# Technical Service Information

## THM 3T40 (125C) FRONT SEAL POP OUT

Figure 1

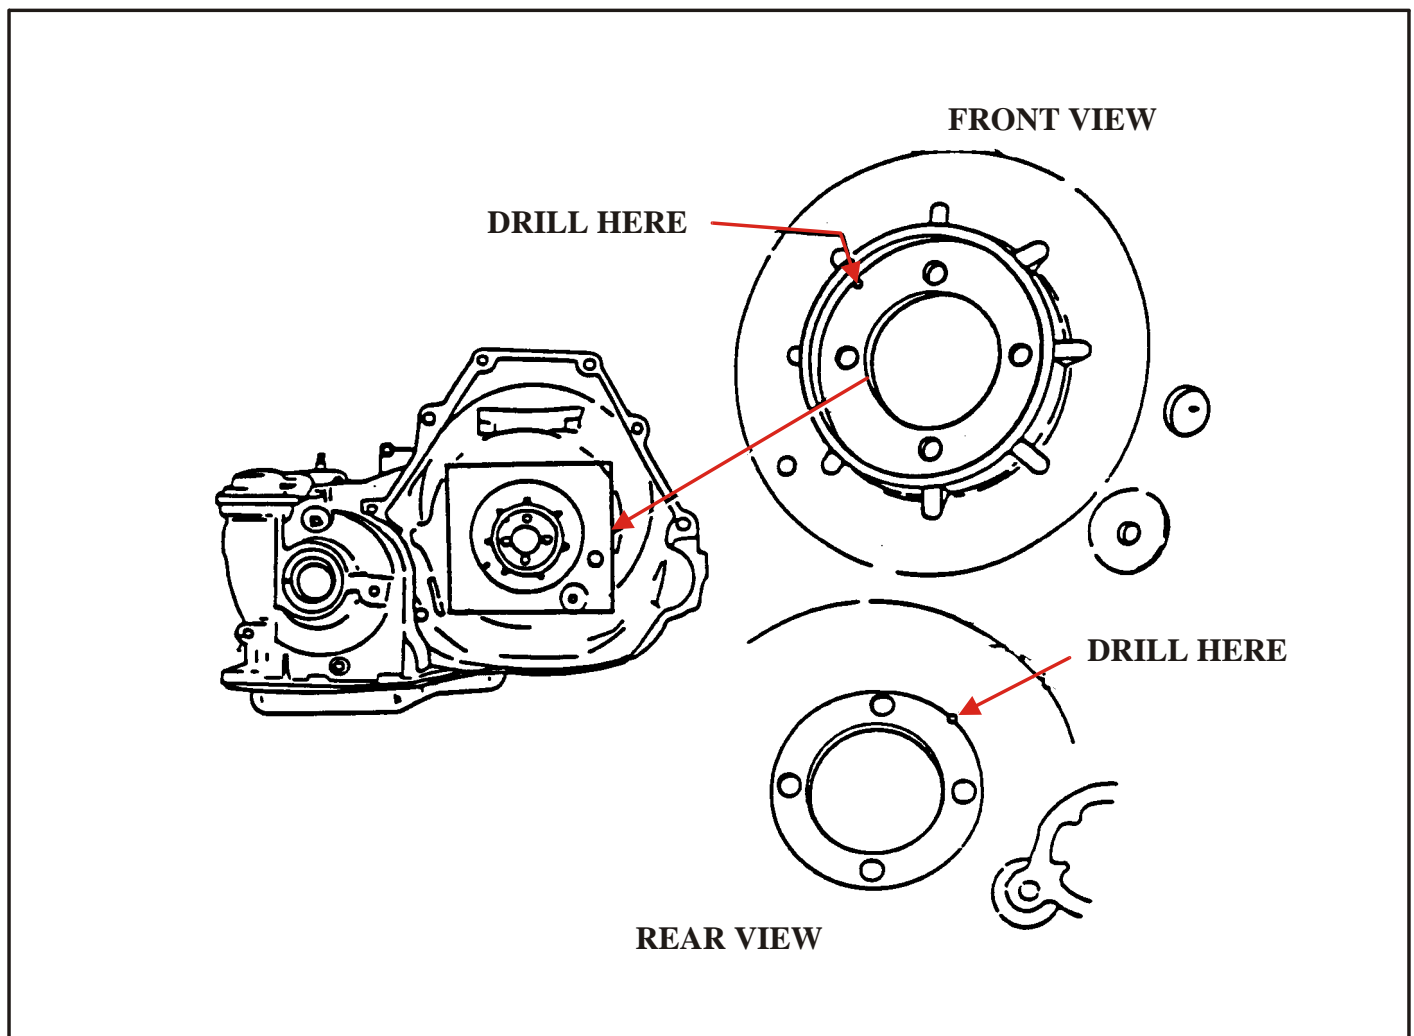
**COMPLAINT:** Front Seal Pop Out

**CAUSE:** One cause can be excessive clearance between the torque converter bushing and the stator support journal area. Wear on the stator support or distortion in the case bore can cause a build up of fluid behind the seal forcing it out of the case.

**CORRECTION** Drill a drain back hole at the 11 or 1 O-Clock position as shown to allow the fluid to drain back into the case before a fluid-pressure build up can cause the seal to pop Out. Use a 1/4" drill bit.
